GUSSIE NELL DAVIS
RANGERETTE RESIDENCE
KILGORE COLLEGE

Addendum No. 1
to the Proposal Documents for
GUSSIE NELL DAVIS RANGERETTE RESIDENCE
KILGORE COLLEGE
Kilgore, Texas

Addendum No. 2
to the Proposal Documents for
GUSSIE NELL DAVIS RANGERETTE RESIDENCE
KILGORE COLLEGE
Kilgore, Texas

Addendum No. 3
to the Proposal Documents for
GUSSIE NELL DAVIS RANGERETTE RESIDENCE
KILGORE COLLEGE
Kilgore, Texas

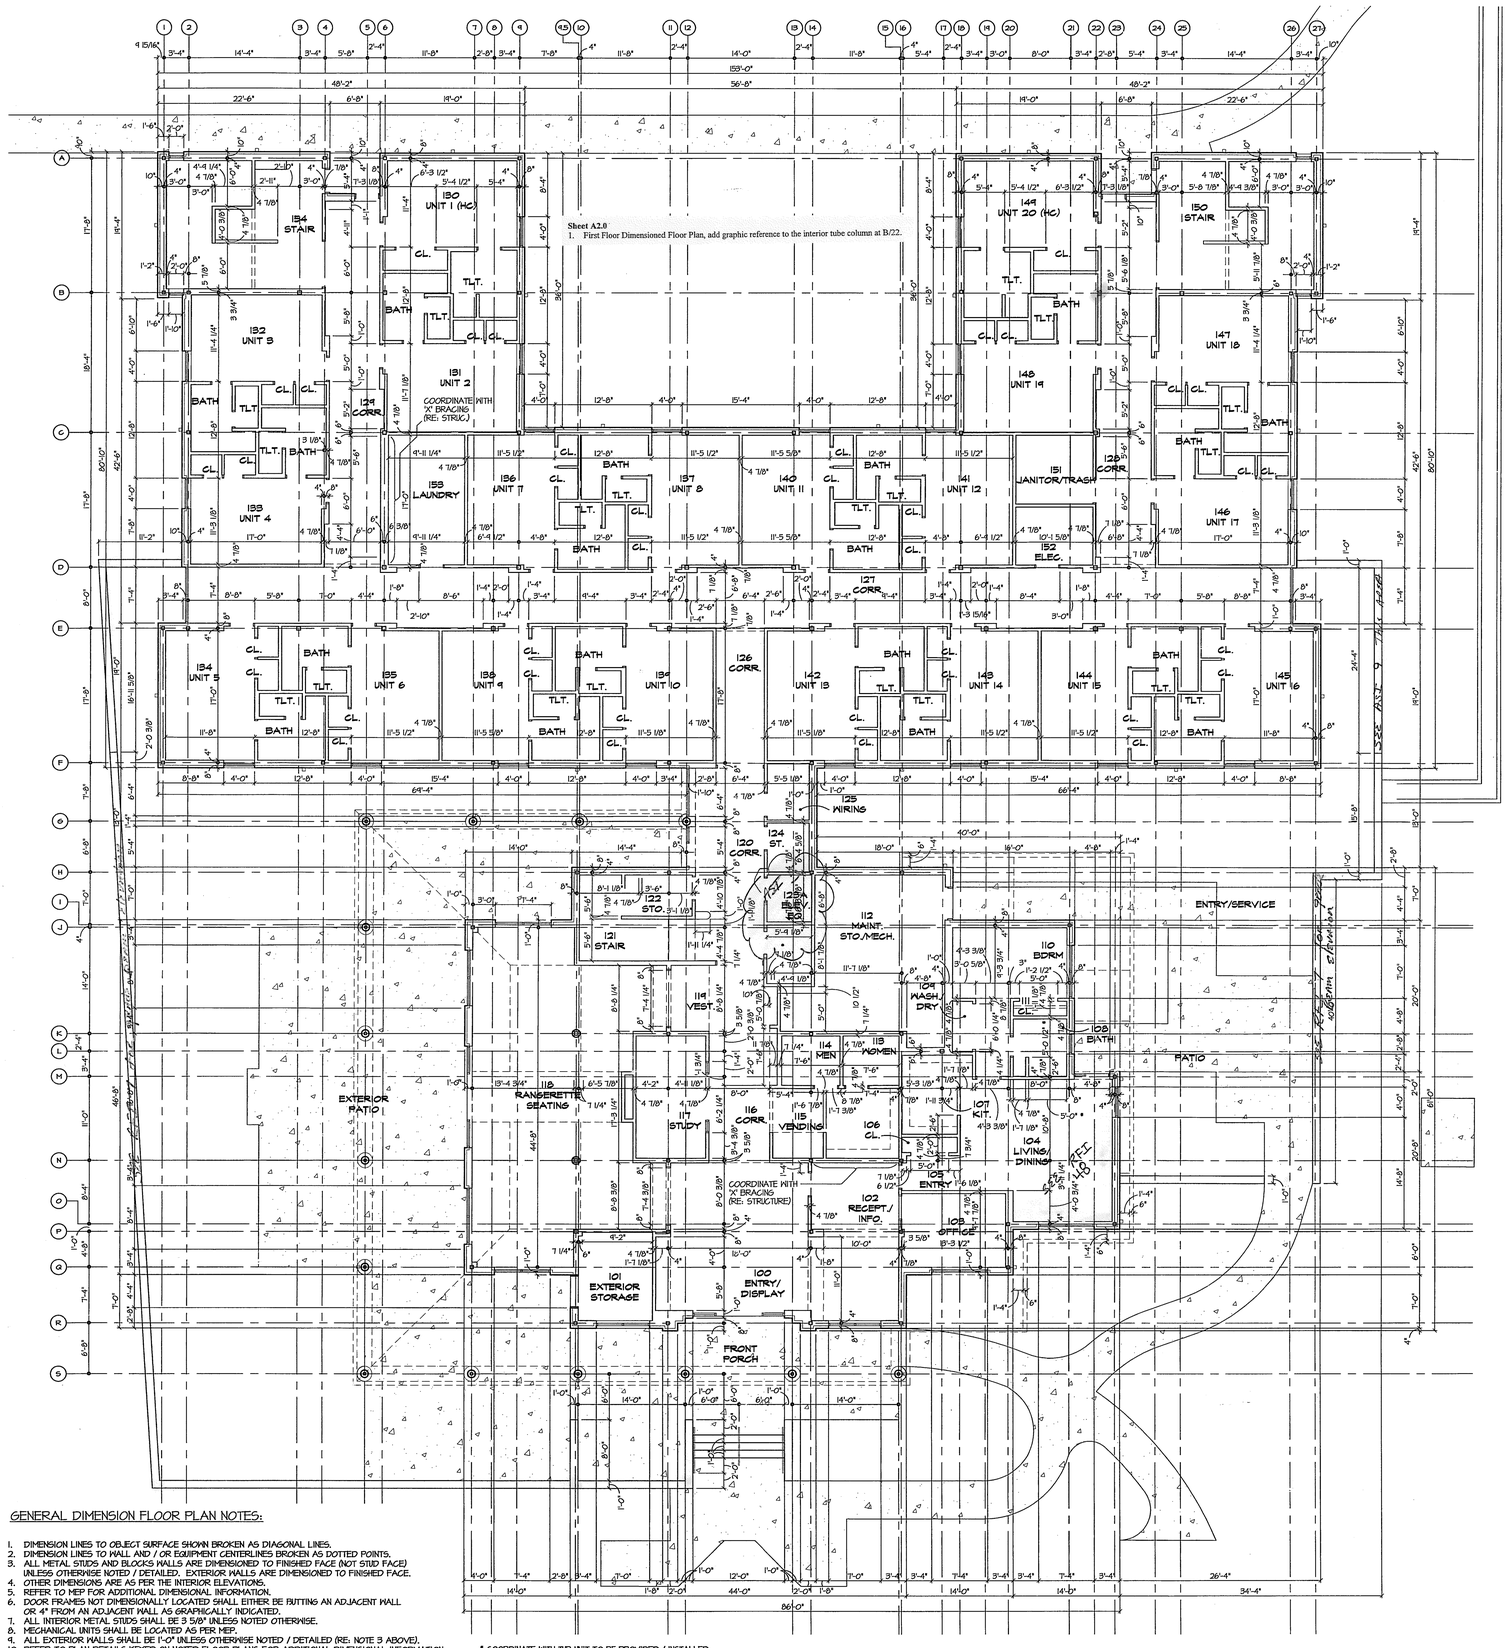
Sheet A2.0
1. First Floor Dimensioned Floor Plan, add graphic reference to the interior tube column at B/22.
130 UNIT 1 (HC)
131 UNIT 2
132 UNIT 3
133 UNIT 4
134 UNIT 5
135 UNIT 6
136 UNIT 7
137 UNIT 8
138 UNIT 9
139 UNIT 10
140 UNIT 11
141 UNIT 12
142 UNIT 13
143 UNIT 14
144 UNIT 15
145 UNIT 16
146 UNIT 17
147 UNIT 18
148 UNIT 19
149 UNIT 20 (HC)
150 STAIR
151 JANITOR/TRASH
152 ELEC.
153 LAUNDRY
154 STAIR
120 CORR.
121 STAIR
122 STO.
123 ELEC. EQ.
124 ST.
125 WIRING
126 CORR.
127 CORR.
128 CORR.
129 CORR.
100 ENTRY/ DISPLAY
101 EXTERIOR STORAGE
102 RECEPT./ INFO.
103 OFFICE
104 LIVING/ DINING
105 ENTRY
106 CL.
107 KIT.
108 BATH
109 WASH./ DRY
110 BDRM.
111 CL.
112 MAINT. STO./MECH.
113 WOMEN
114 MEN
114 VEST.
115 VENDING
116 CORR.
117 STUDY
118 RANGERETTE SEATING
EXTERIOR PATIO
PATIO
ENTRY/SERVICE
COORDINATE WITH 'X' BRACING (RE: STRUCT.)
COORDINATE WITH 'X' BRACING (RE: STRUCTURE)
1'-6" FFE
1'-0" FFE
1'-4" FFE
1'-0" FFE
1'-4" FFE
1'-0" FFE
1'-4

Sheet A2.1

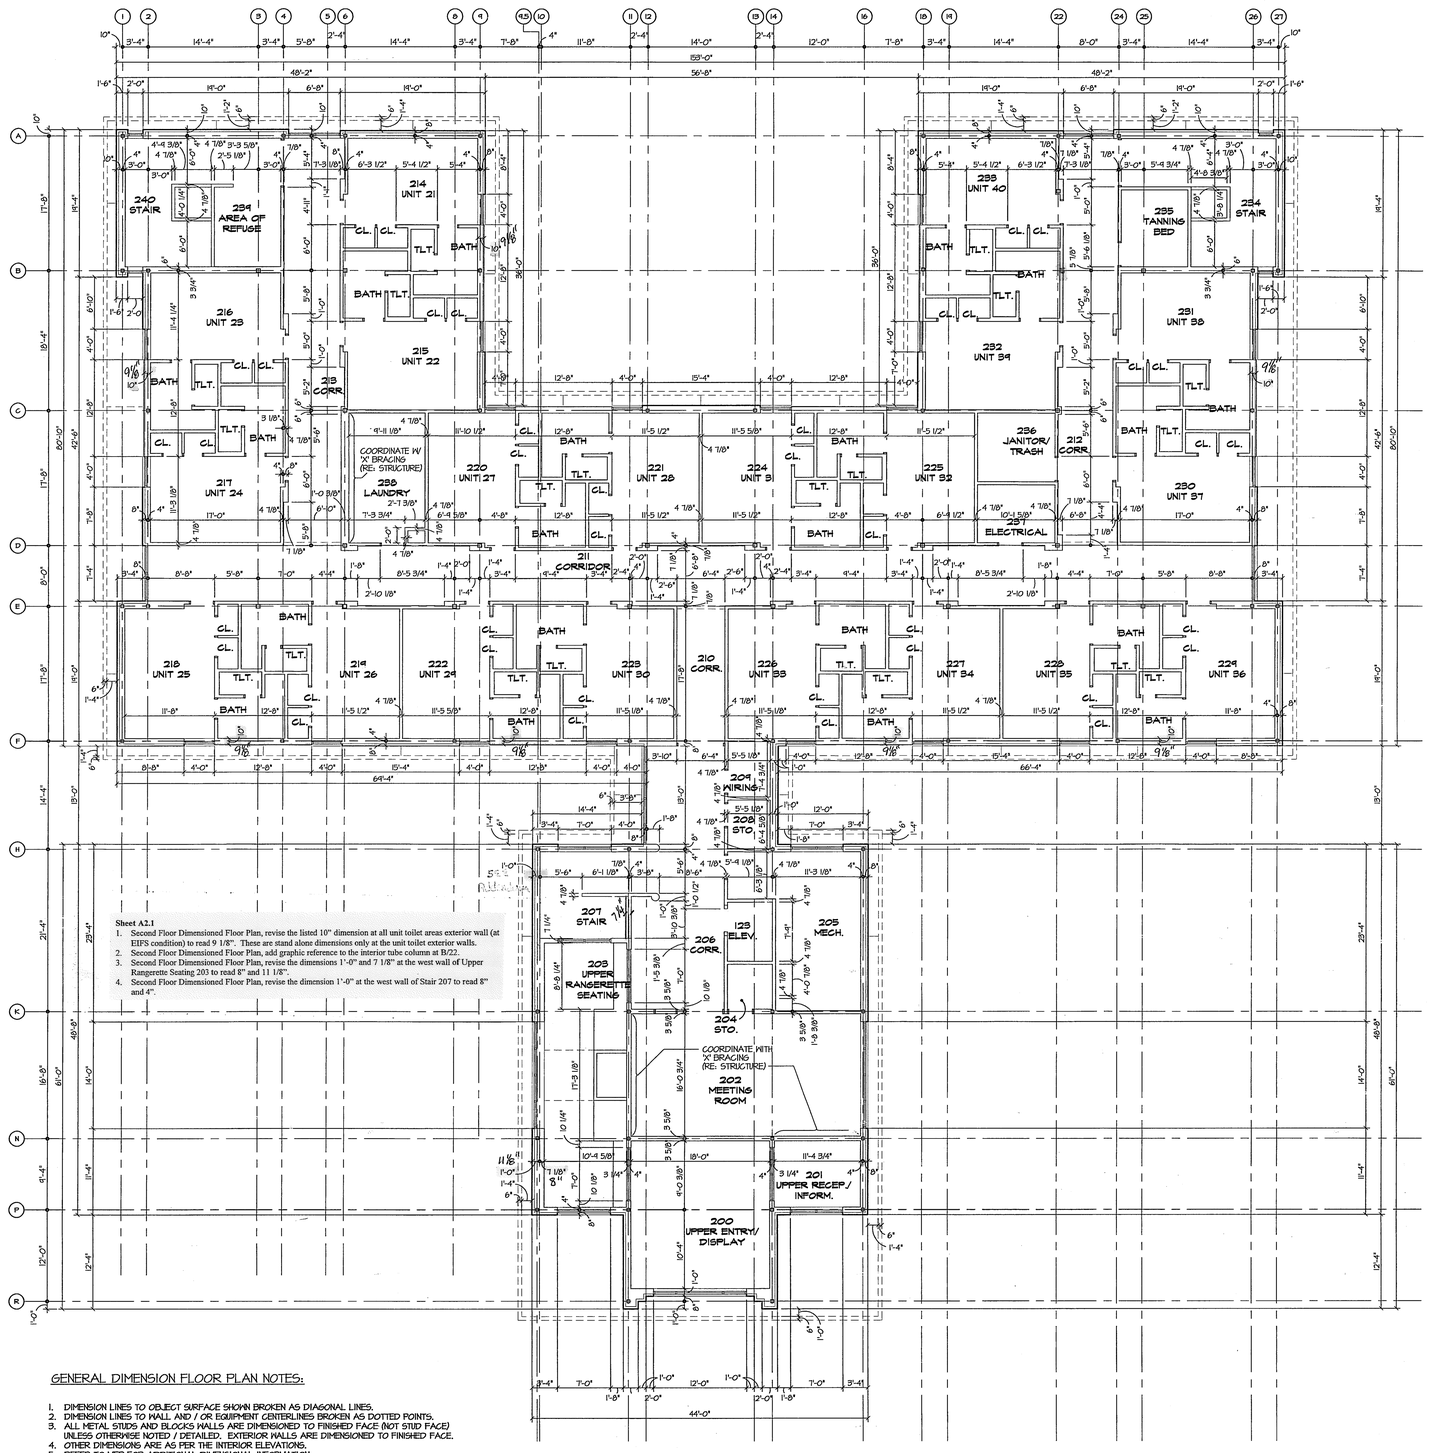
1. Second Floor Dimensioned Floor Plan, revise the listed 10" dimension at all unit toilet areas exterior wall (at EIFS condition) to read 9 1/8". These are stand alone dimensions only at the unit toilet exterior walls.
2. Second Floor Dimensioned Floor Plan, add graphic reference to the interior tube column at B/22.
3. Second Floor Dimensioned Floor Plan, revise the dimensions 1'-0" and 7 1/8" at the west wall of Upper Rangerette Seating 203 to read 8" and 11 1/8".
4. Second Floor Dimensioned Floor Plan, revise the dimension 1'-0" at the west wall of Stair 207 to read 8" and 4".

Sheet A2.2

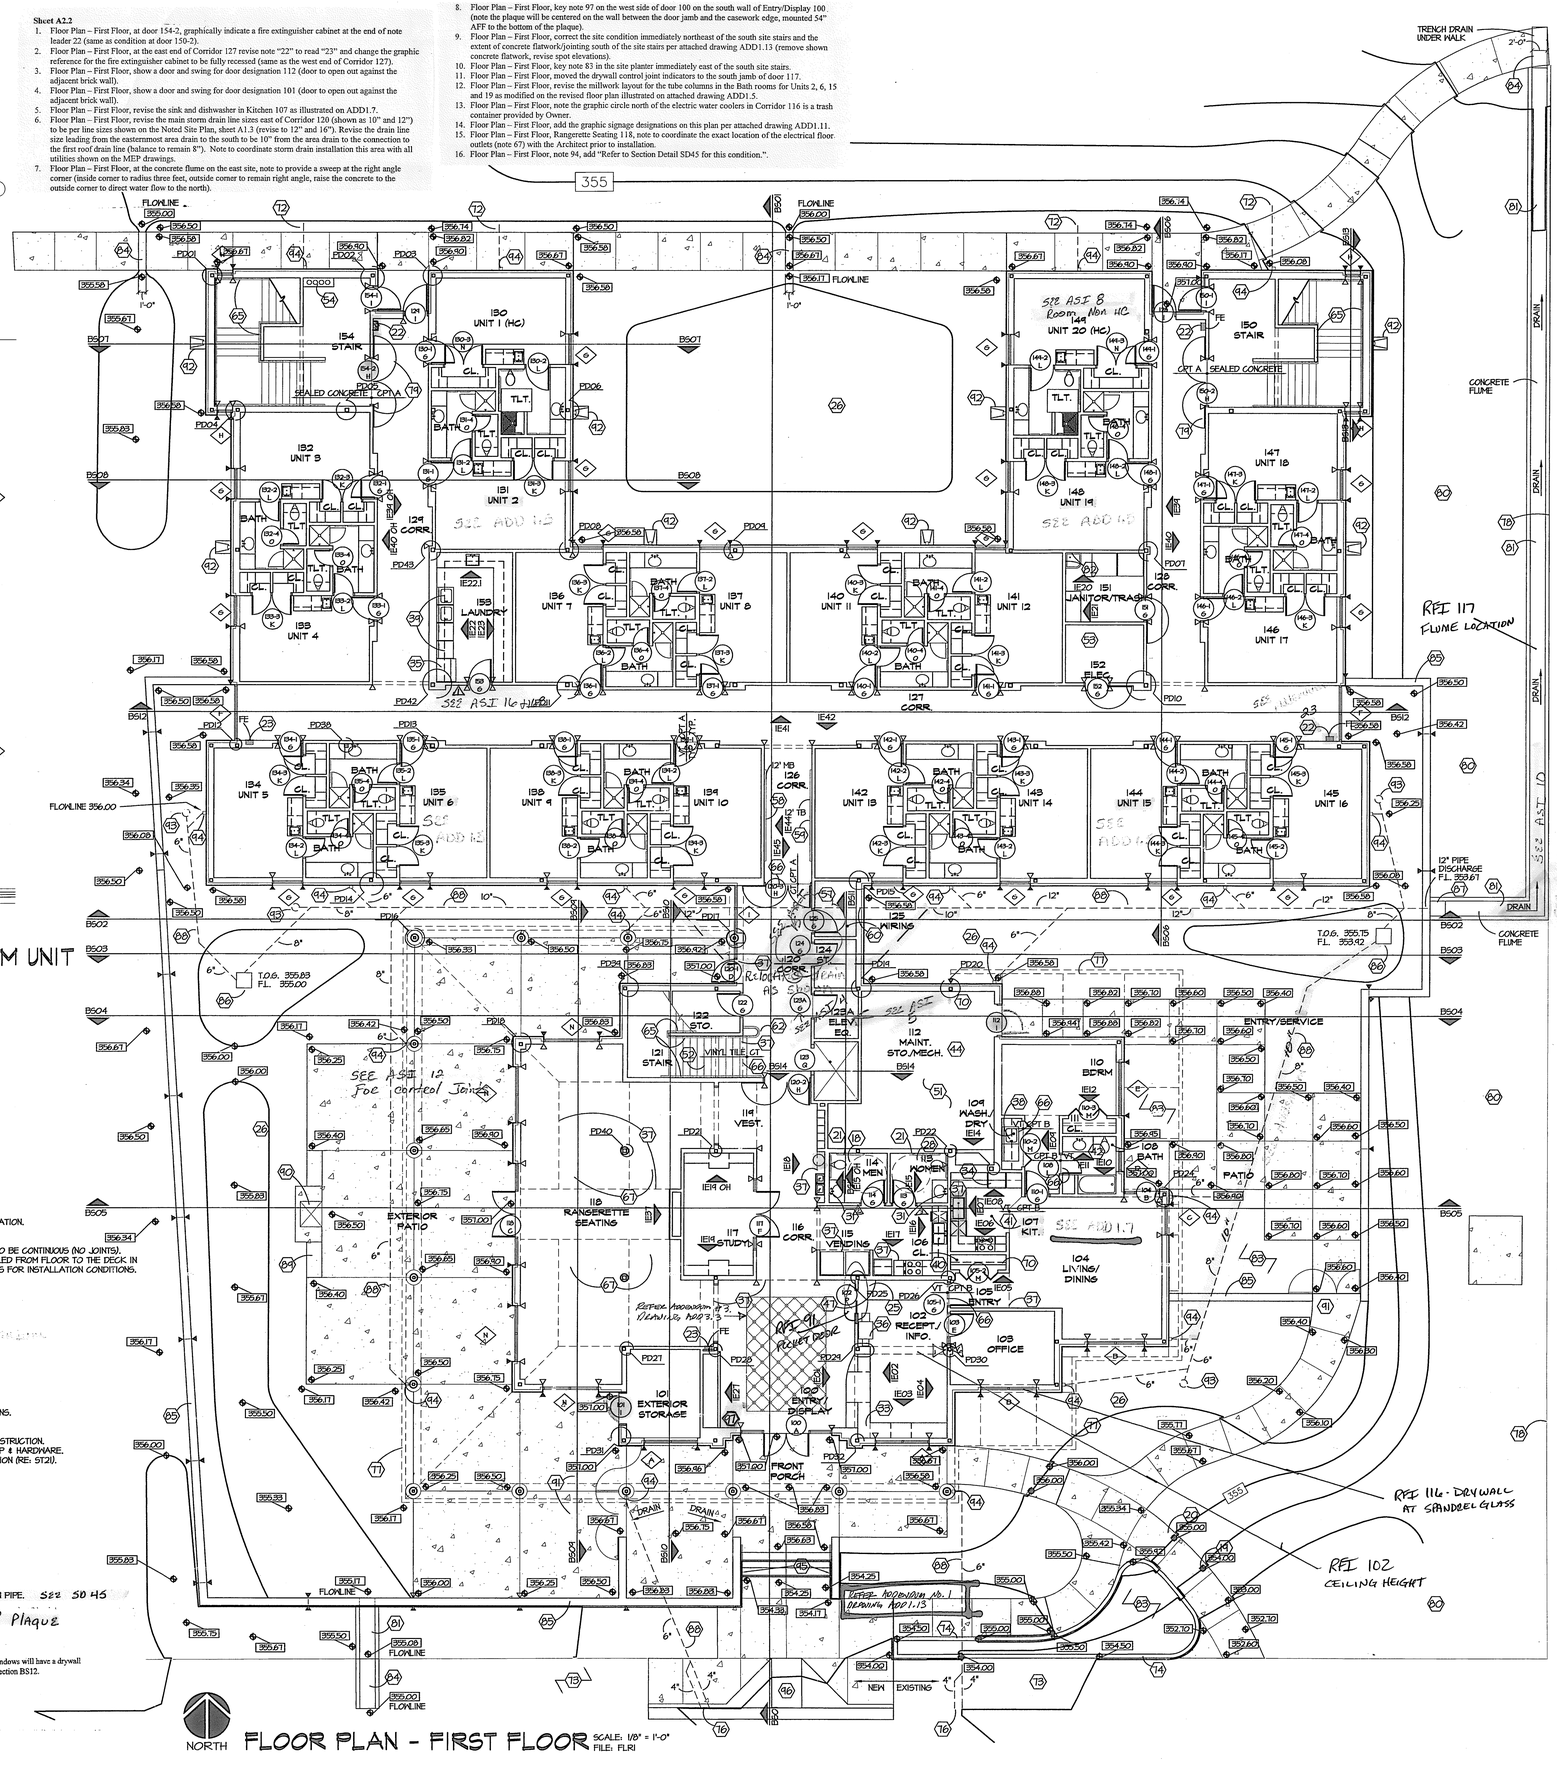
9. Floor Plan – First Floor, correct the site condition immediately northeast of the south site stairs and the extent of concrete flatwork/jointing south of the site stairs per attached drawing ADD1.13 (remove shown concrete flatwork, revise spot elevations).

12. Floor Plan – First Floor, revise the millwork layout for the tube columns in the Bath rooms for Units 2, 6, 15 and 19 as modified on the revised floor plan illustrated on attached drawing ADD1.5.

13. Floor Plan – First Floor, note the graphic circle north of the electric water coolers in Corridor 116 is a trash container provided by Owner.
14. Floor Plan – First Floor, add the graphic signage designations on this plan per attached drawing ADD1.11.

15. Floor Plan – First Floor, Rangerette Seating 118, note to coordinate the exact location of the electrical floor outlets (note 67) with the Architect prior to installation.

16. Floor Plan – First Floor, note 94, add "Refer to Section Detail SD45 for this condition.".

REFER TO SHEET A2.2 FOR NOTATION
SECOND FLOOR PLAN SCALE: 1/8" = 1'-0" FILE: FLR2

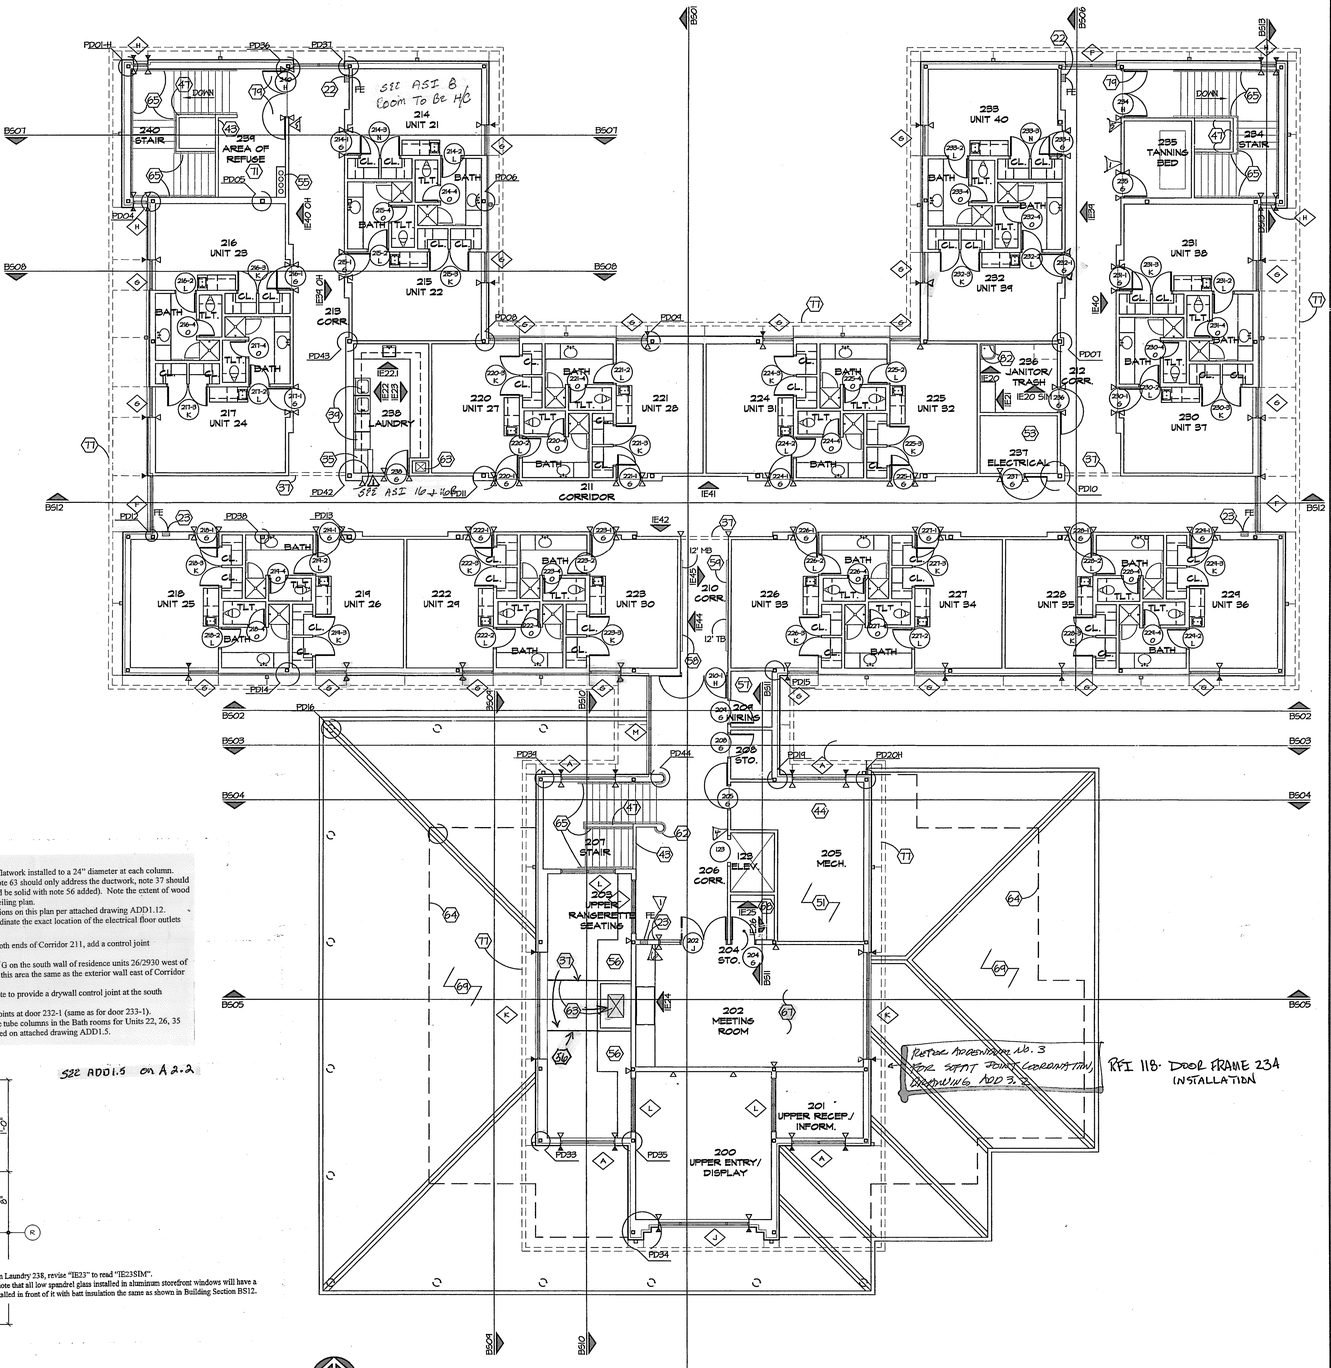
1. Plan Detail PD16, note the circle shown is concrete flatwork installed to a 24" diameter at each column.
2. Second Floor Plan, upper Rangerette Seating 203, note 63 should only address the ductwork, note 37 should point to both sides of the furring line (this line should be solid with note 56 added). Note the extent of wood molding in this space is addressed on the reflected ceiling plan.

3. Second Floor Plan, add the graphic signage designations on this plan per attached drawing ADD1.12.
4. Second Floor Plan, Meeting Room 202, note to coordinate the exact location of the electrical floor outlets (note 67) with the Architect prior to installation.

9. Second Floor Plan, revise the millwork layout for the tube columns in the Bath rooms for Units 22, 26, 35 and 39 as modified on the revised floor plan illustrated on attached drawing ADD1.5.

1. Second Floor Plan, in Laundry 238, revise "IE23" to read "IE23SIM".
2. Second Floor Plan, note that all low spandrel glass installed in aluminum storefront windows will have a drywall partition installed in front of it with batt insulation the same as shown in Building Section BS12.
